RESPONSES TO COMMENTS ON THE DRAFT ENVIRONMENTAL IMPACT REPORT

SFPUC Alameda Creek Recapture Project Volume 3

PLANNING DEPARTMENT
CASE NO. 2015-004827ENV
STATE CLEARINGHOUSE NO. 2015062072
JUNE 7, 2017

Re: **Responses to Comments on the Draft Environmental Impact Report for
Case No. 2015-004827ENV, SFPUC Alameda Creek Recapture Project**

Figure 11.5-1

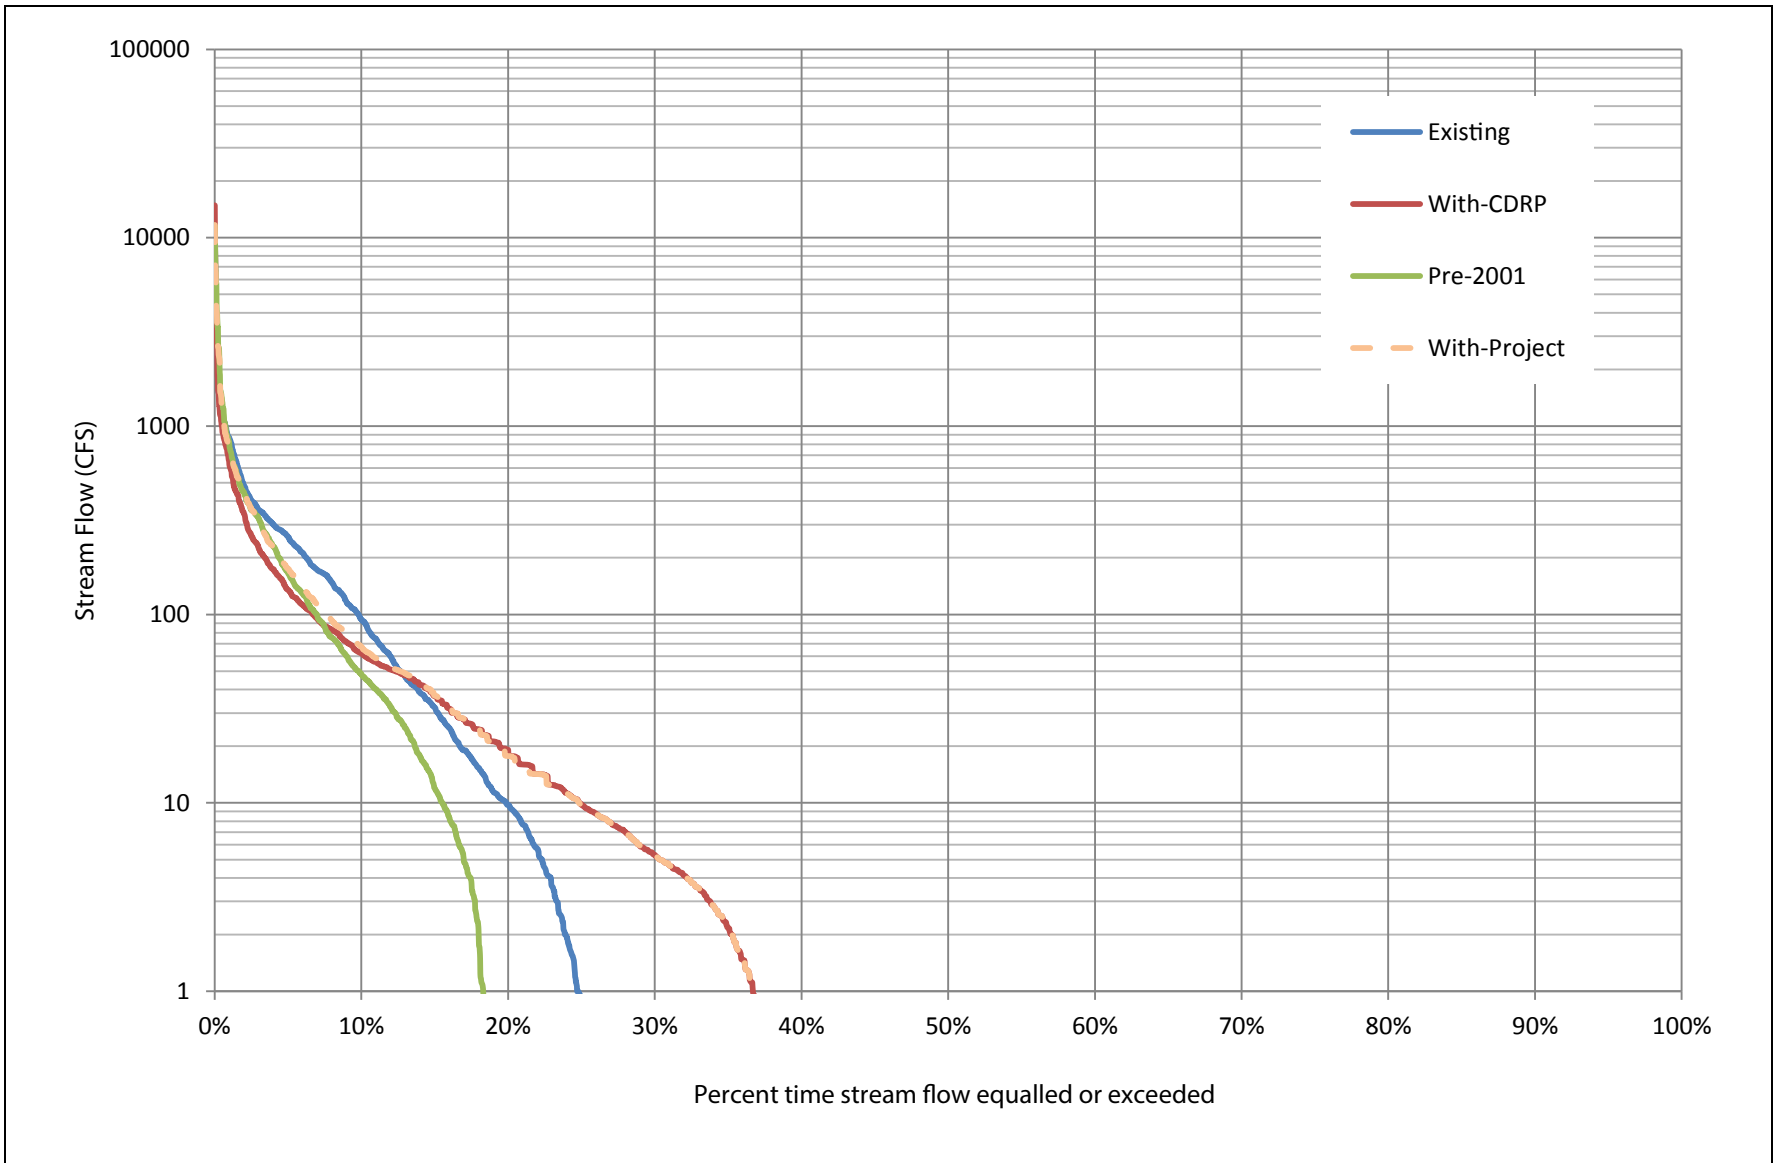
Comment A-NMFS-1 requests information on the number of days there is a surface water flow connection through the Sunol Valley to assist in assessing the ACRP’s potential effects on steelhead migration and the duration of flows for seasonal rearing of juvenile steelhead in the Sunol Valley. The number of days of surface water flow connection through Sunol Valley is not stated explicitly in the EIR but can be deduced from information provided in the EIR itself and Appendix HYD1 (Figures 5.16-3, 5.16-4, 5.16-5 in the EIR, pp. 5.16-13 to 5.16-16, and Section 5.16.2.4, pp. 5.16-11 to 5.16-18 in Chapter 5; and Section 5.3, pp. 61 to 76; and Section 5.3, pp. 61 to 76, Section 6.2, pp. 80 to 98, and Figures HYD5-5, HYD5-6, HYD5-7, HYD6-3, HYD6-4 and HYD6-5, pp. 63, 64, 66, 86 to 88, in Appendix HYD1). The results of the analysis of when there is a surface water connection through the Sunol Valley are shown in **Table 5.11-1**. For there to be continuous flow through Sunol Valley, there would need to be flow at both Nodes 5 and 7 on the same day, regardless of the flow at Node 4. An explanation of how the results were arrived at is provided below.

Figure HYD5-5 in Appendix HYD1 (p. 63) shows flow-duration curves for pre-2001 conditions, existing conditions, and with-CDRP conditions at the Alameda Creek/Welch Creek confluence (Node 4). **Figure 11.5-1** shows the same information, but with the addition of a flow-duration curve for with-project conditions. The figure shows that on about 52 percent of the days under pre-2001 conditions and on about 42 percent of the days under existing conditions, Alameda Creek is dry, or almost dry, at the Welch Creek confluence; or conversely, as indicated in Table 11.5-1, there would flow in the creek on 48 percent of the days under pre-2001 conditions, and 58 percent of the days under existing conditions. Under pre-2001 conditions, the SFPUC operated Calaveras Reservoir in accordance with the SFPUC's pre-1914 appropriative water rights and continues to do so under existing conditions. Under both with-CDRP and with-project conditions, flow would continue past the Welch Creek confluence every day and the creek channel would never be dry. This is a result of the releases at Calaveras Reservoir and the bypasses at the Alameda Creek Diversion Dam that are a part of with-CDRP and with-project conditions.

SFPUC Alameda Creek Recapture Project
Revised Figure 1-1
 Project Vicinity Map

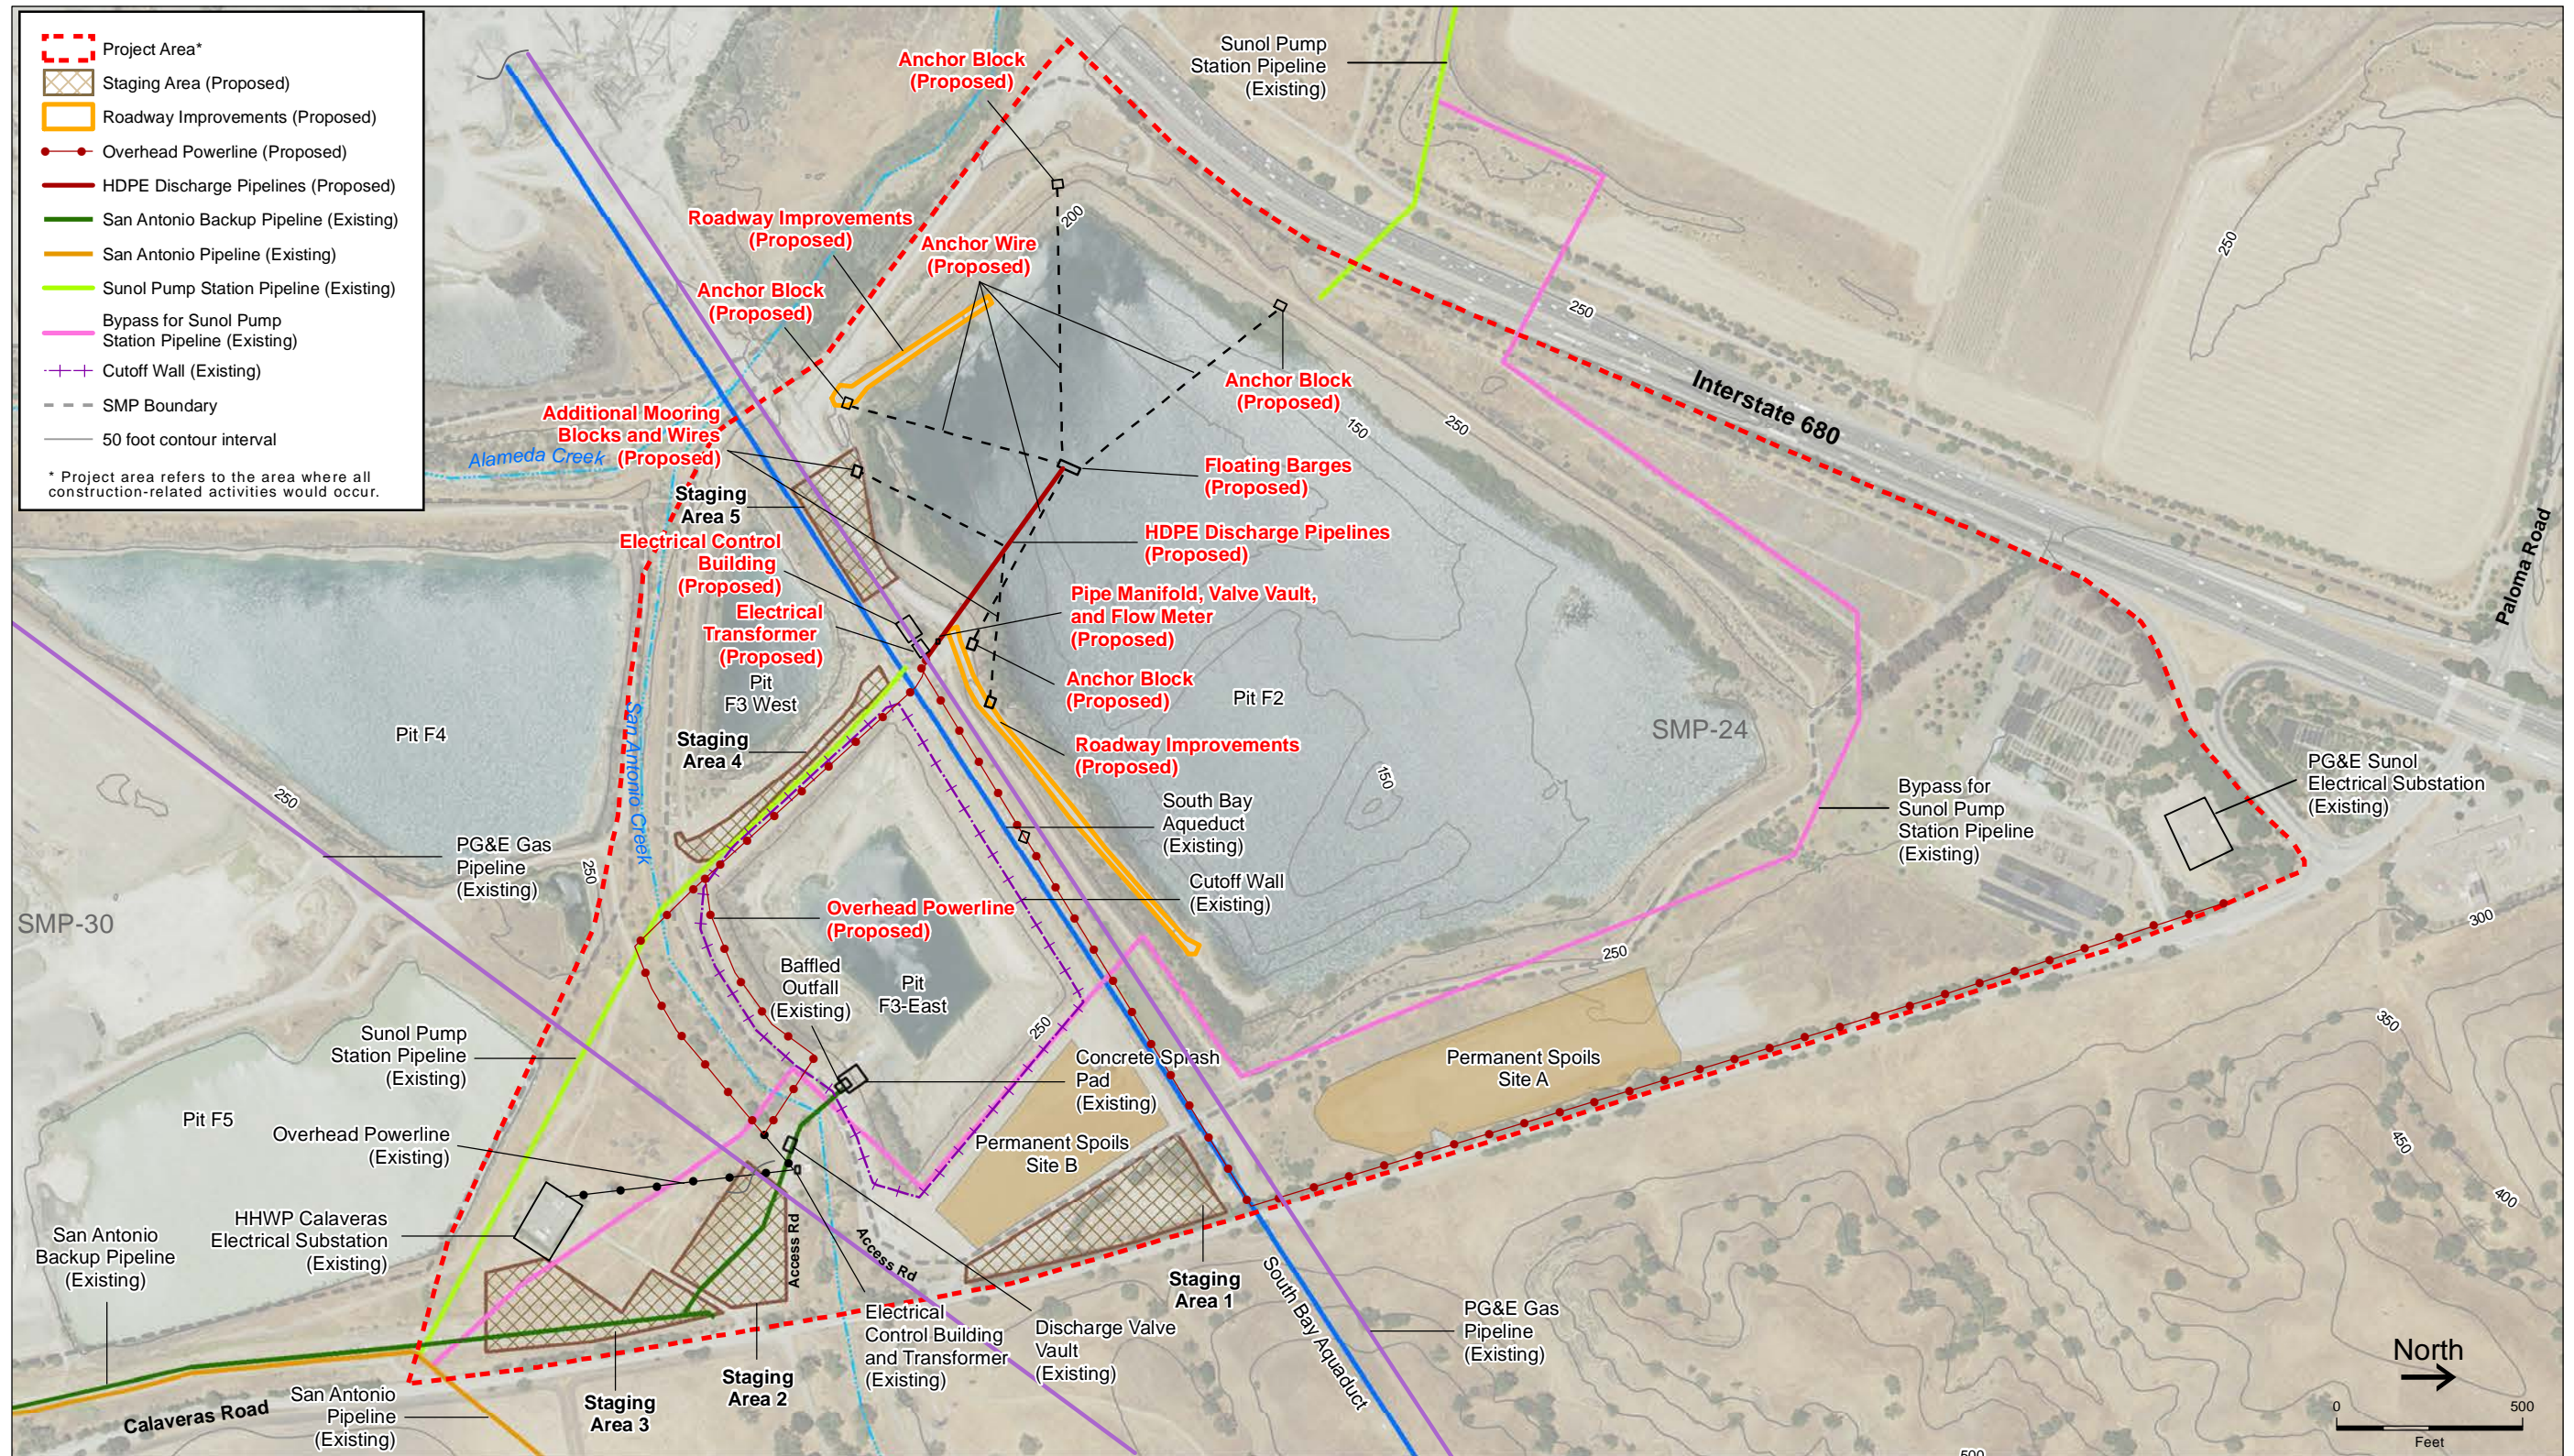
f. **The DEIR cumulative impacts do not include effects of cutoff walls.** Figure 1-1 of the DEIR displays existing cutoff walls around Pit F2, which were installed to minimize seepage of Alameda Creek surface water into the groundwater basin and into Pit F2. The figure also displays proposed future cutoff walls around sections of Pit F6. Installation of this future cutoff wall will likely provide additional protection from surface streamflow losses to the Sunol groundwater basin. The hydrologic analysis must be refined to include the proposed cutoff wall, and any associated changes in streamflow loss rate to determine cumulative impacts and adequately model future streamflow conditions through this reach (CEQA Guidelines §§ 15065(a)(3), 15130). (Robert Shaver, General Manager, Alameda County Water District, January 30, 2017, A-ACWD2-10)

- 1.) In Figure 1-1 of the DEIR, it appears that surface water flow originating from rainfall has the ability to run directly into Pit F2. Former nurseries are located immediately adjacent to the north and south of Pit F2. The DEIR must include a comprehensive analysis and assessment at this location to ensure that surface soil is not contaminated in the vicinity of Pit F2. Contaminated surface soil could impact the water quality of surface runoff to Pit F2.

In response to this comment, Figure 1-1 and Figure 3-2 in the EIR (identical figures) have been revised to remove the proposed cutoff wall because it currently does not exist. This revision does not change the analysis or conclusions of the EIR.

As discussed in Response HY-9, Figure 1-1, page 1-3 has been revised to remove the proposed cutoff wall because it currently does not exist, as shown on page 12-3. See Revised Figure 1-1.
